## PRODUCT CHANGE NOTIFICATION

Date: February 28<sup>th</sup>, 2020  
PCN: PCN LEDIL 158

Subject: PCN 158 - Change of design in LINNEA product family

NEW:

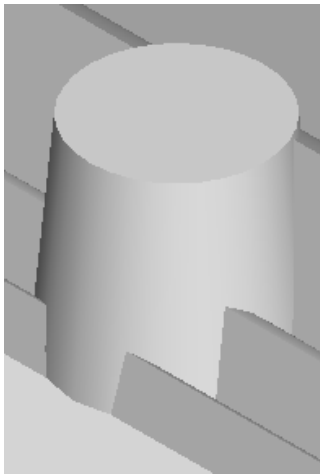
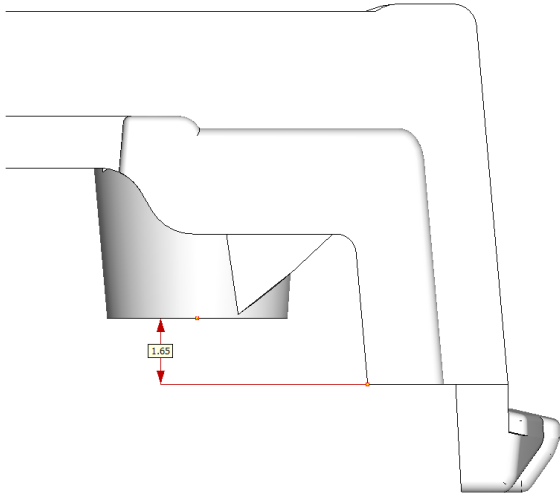
Description: As part of our continuous improvement process regarding the quality of our products, LEDiL has decided to change pin design in LINNEA product family. This is due to make pin parts inside the lens more durable.
